CITY OF MERCER ISLAND
APPLICATION FOR WAIVER OF STEEP SLOPE PROCEDURE(S)

JOB ADDRESS: 9640 SE 61st Place
LEGAL DESCRIPTION Lot 6, Leland Addition, Govt lot 4, Section 19 T24N R5E SEE ATTACHED
OWNER: Pat Dunbar + Mike Jeffrey TEL. NO. 236-2683
ARCHITECT: _____ TEL. NO. _____
DATE PERMIT APPLIED FOR: 12/30/88 DATE WAIVER APPLIED FOR: 12/30/88

**City of Mercer Island
Condition to Steep Slope Waiver
9640 SE 61st Place
Dunbar/Jeffrey Residence**

PLOT PLAN OF BUILDING SITE
DUNBAR/JEFFREY RESIDENCE

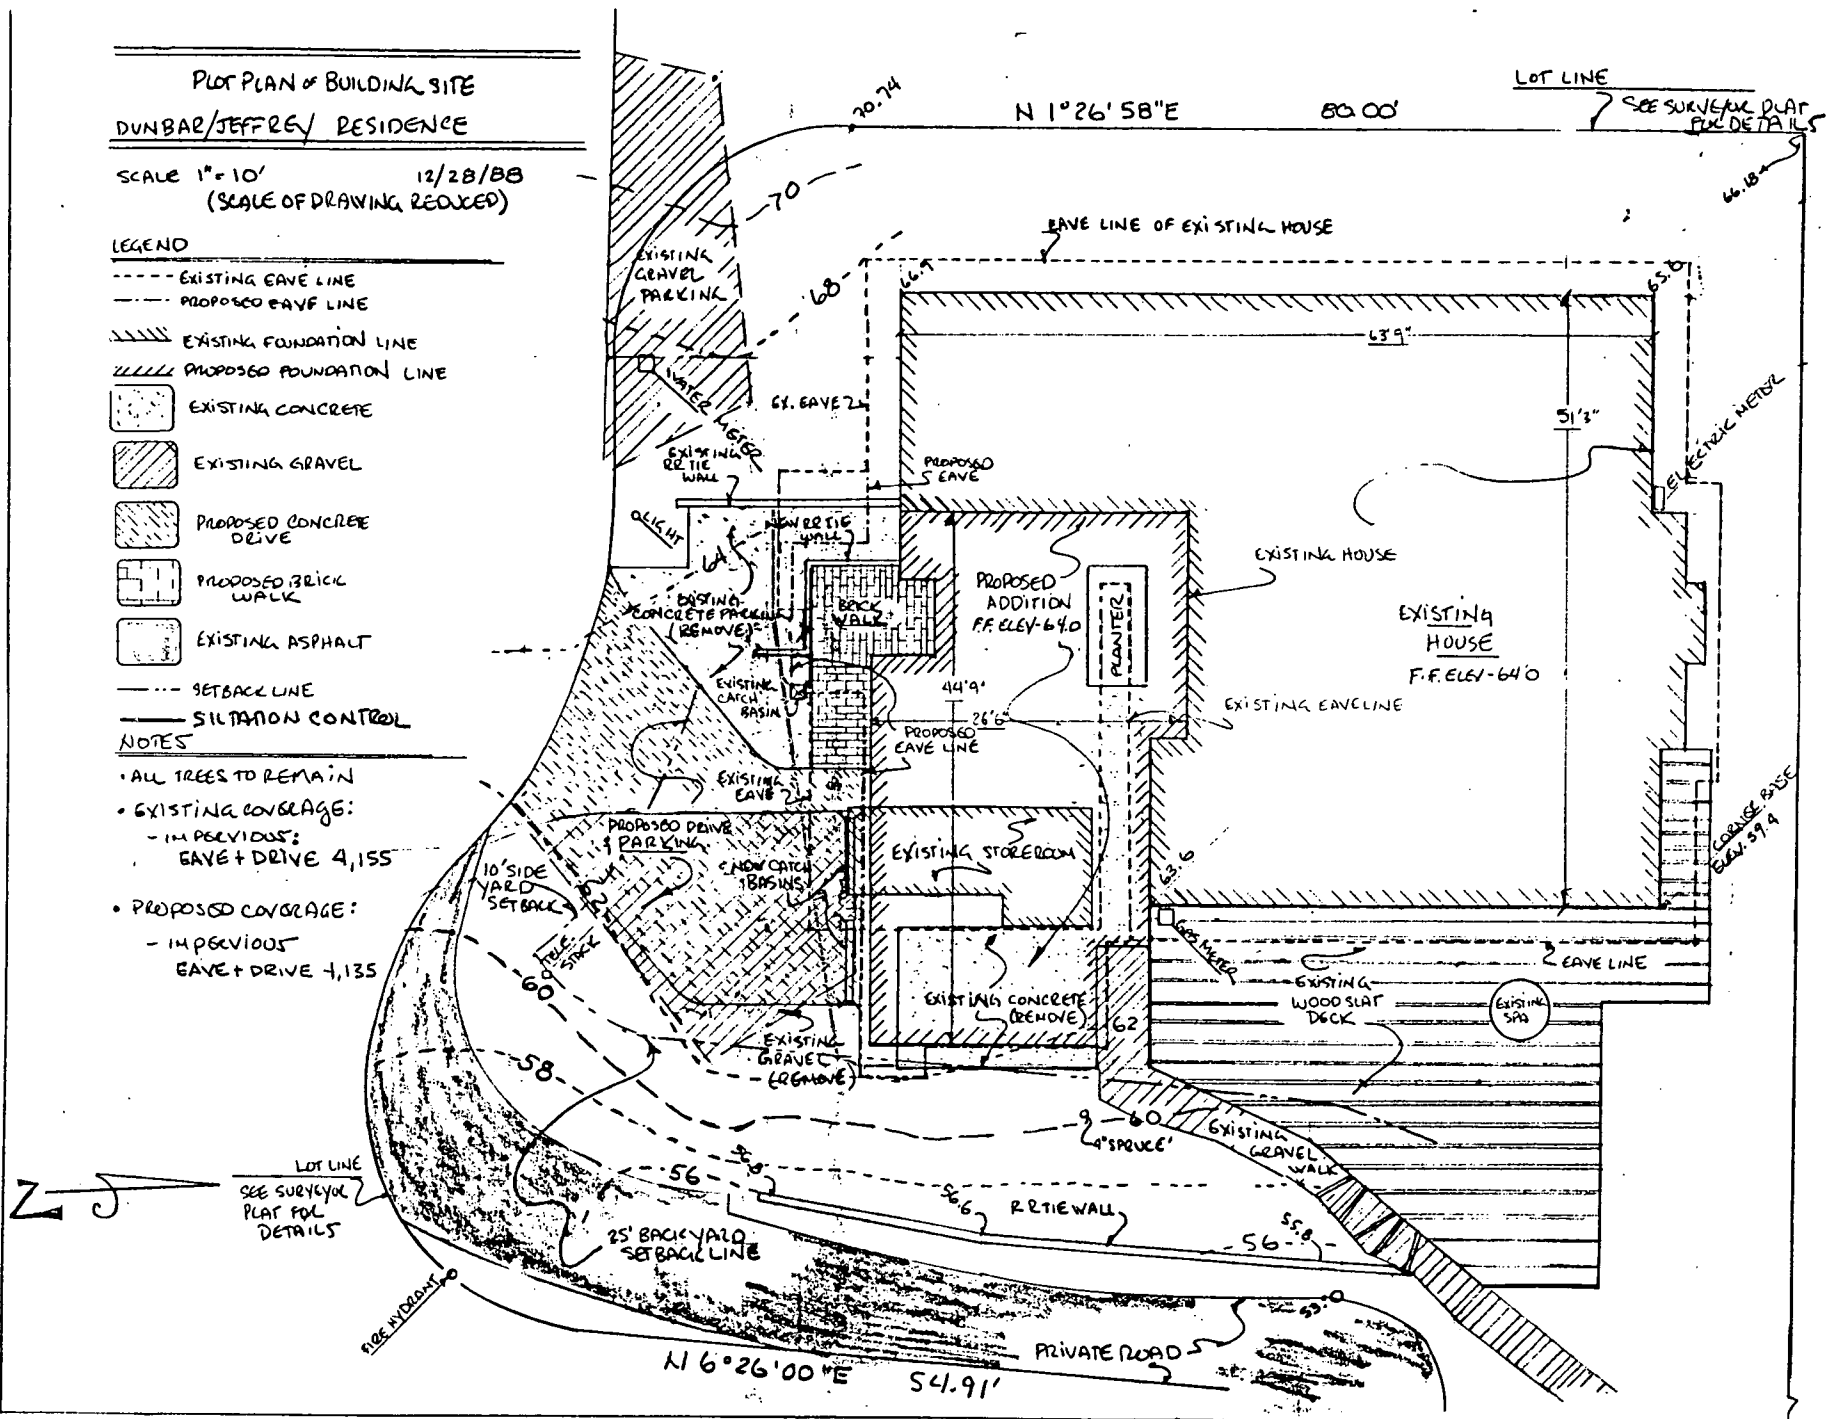
1. ALL DRAINAGE MUST BE CONNECTED TO AN EXISTING SYSTEM. IF NO SYSTEM EXISTS, A LINE WILL BE REQUIRED TO CONVEY STORM WATER TO AN APPROVED DRAINAGE SYSTEM OR TO THE LAKE.
2. THE EXCAVATION FOR THE NEW FOUNDATION ALONG THE EAST SIDE OF THE GARAGE WILL REQUIRE SPECIAL EMPHASIS ON SILTATION CONTROL AND MUST BE CUT INTO THE BANK SUFFICIENTLY TO PROVIDE A 5' SETBACK FROM THE FACE OF THE SLOPE TO THE FACE OF THE FOOTING.
3. PROVIDE A STORMWATER & SILTATION PLAN

All drainage systems will be 4" drain tight line system tied into existing drainage system.

Siltation control will be by means of a fabric mesh wall with 6 mil visquen behind for siltation entrapment. No siltation will permeate outside of construction or into storm drains.
